MONTGOMERY COUNTY PLANNING DEPARTMENT
THE MARYLAND-NATIONAL CAPITAL PARK AND PLANNING COMMISSION

REVIEW TYPE: Pre-Preliminary Plan of Subdivision, Resubdivision of existing Lot 10

PROJECT NAME: Burnt Mills Village
CASE #: 720060600
REVIEW BASIS: Chapter 50, including Sec. 50-29(b)(2), Montgomery County Subdivision Regulations

RECOMMENDATION: Objection to the submittal of a preliminary plan.

**PRE-PRELIMINARY CONCEPT PLAN
RESUBDIVISION OF LOT 10, BLOCK H
BURNT MILLS VILLAGE**

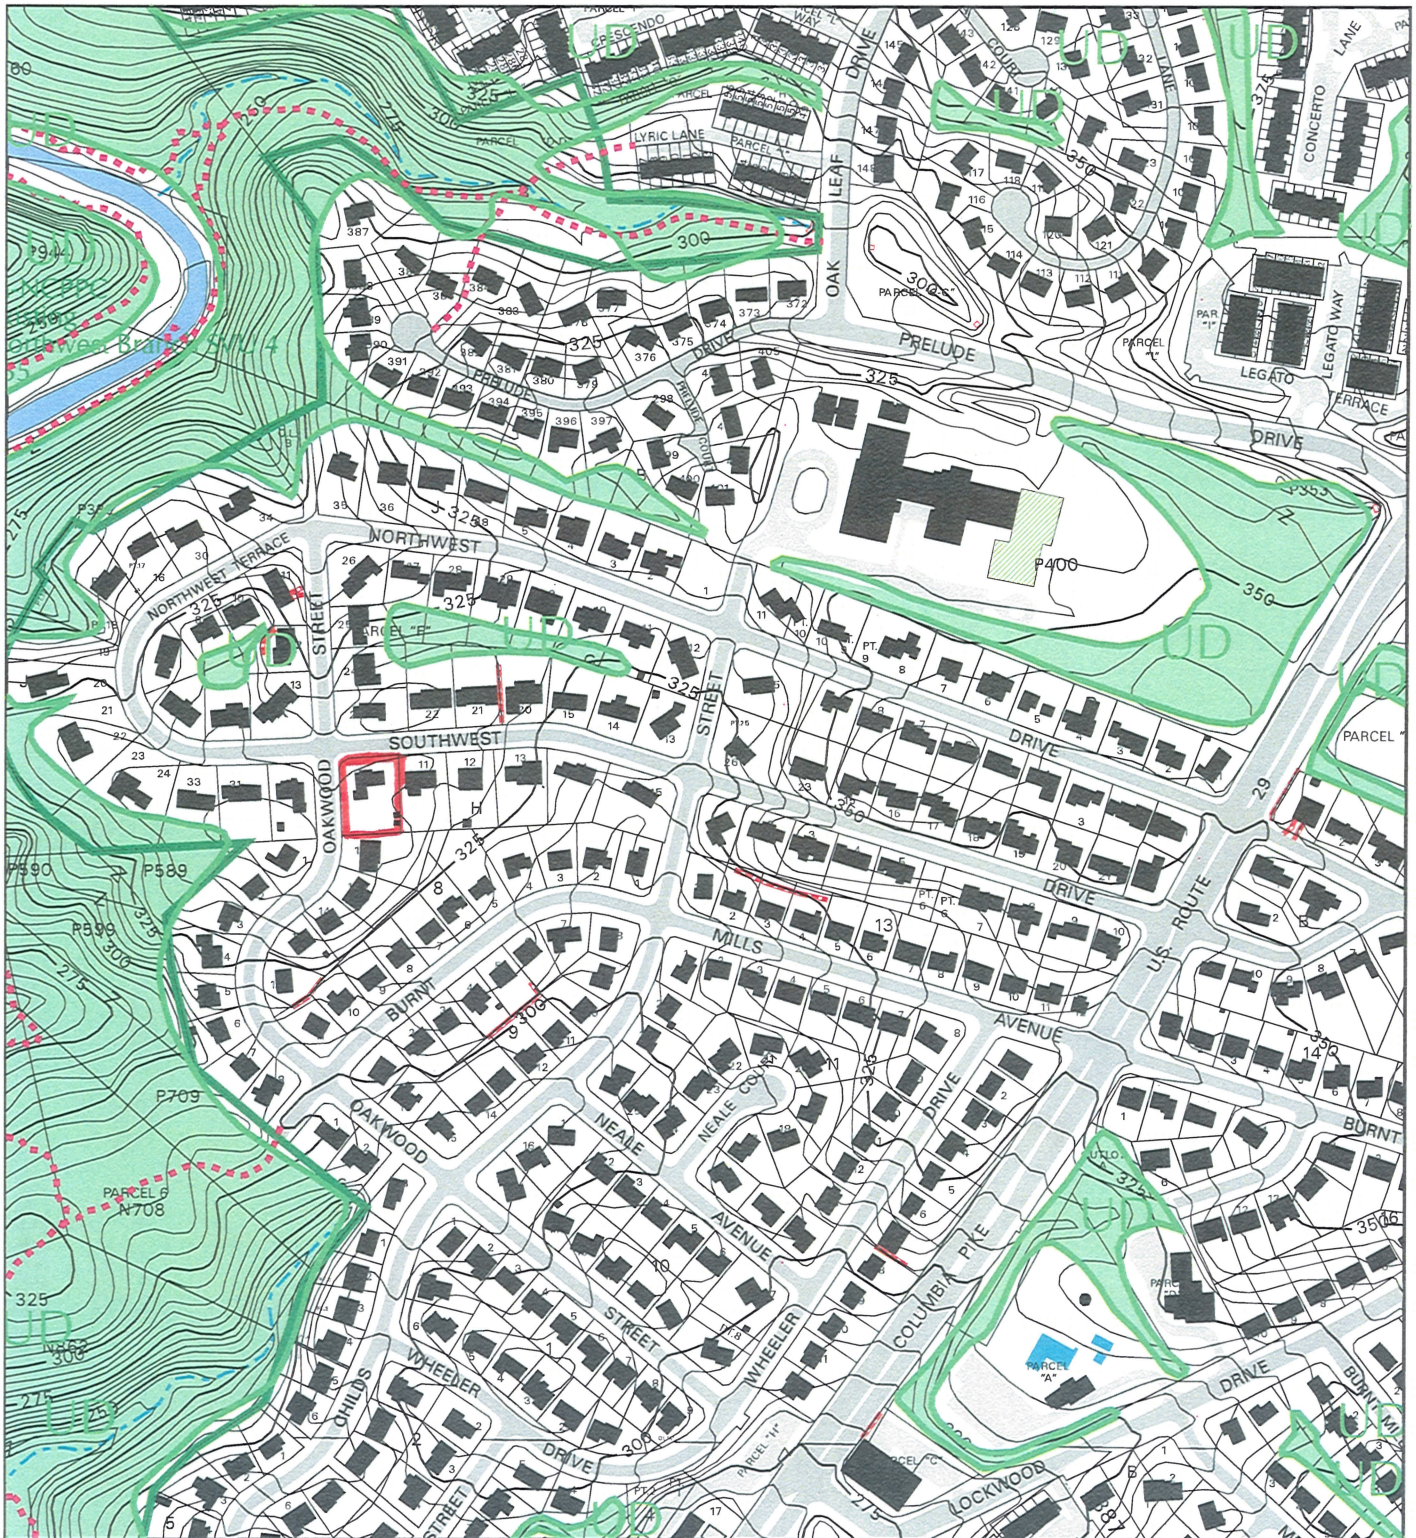
In Staff's opinion, the proposed lots are not in character with respect to lot size and buildable area, and therefore fail to meet the resubdivision test. Staff also finds that the alignment of these two lots along the street opposite the one lot on the confronting corner is out of character with the typical relationship of corner lots on Southwest Drive in the original subdivision. The Applicant argues that two-to-one alignment relationships exist throughout the Burnt Mills Village and Burnt Mills Manor subdivisions, and specifically believes the two proposed lots "mirror" Lots 23 and 24 in Block G and their alignment to Lot 13, Block K across Oakwood Street. When closely examined, the relationship is actually not two-to-one and both Lots 23 and 24 are deeper and larger in size than the two proposed lots.

If a waiver of dedication for truncation is granted, the overall lot size and buildable area of proposed Lot 16 would increase. With truncation, proposed Lot 16 is 9,533 square feet in overall size and contains 2,232 square feet of buildable area. If dedication is not required, proposed Lot 16 would be 9,760 square feet in size and contain 2,863 square feet of buildable area. This would prevent it from having the smallest buildable area in Staff's Neighborhood, but it would remain in the bottom of the range.
